January 16, 2015

Doug Pope City Engineer, City of North Vancouver 141 West 14th Street North Vancouver, BC V7M 1H9

#### **Low Level Road Project Cycling Facilities**

Figure 5: Bike lane with buffer to parked cars

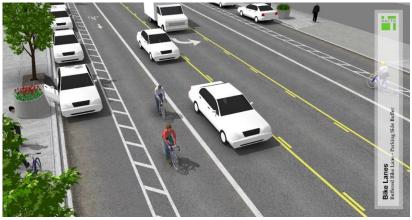
### 9. Mark door buffer between Esplanade bike lanes and parked cars

The new bike lanes on Esplanade are wider than before, but the risk of 'dooring' and subsequent collision with moving traffic remains where parked cars are next to the bike lane. To reduce the risk we recommend striping a buffer in the bike lane next to the parked cars. A 2014 Transportation Research Board report found that buffers were effective<sup>6</sup>:
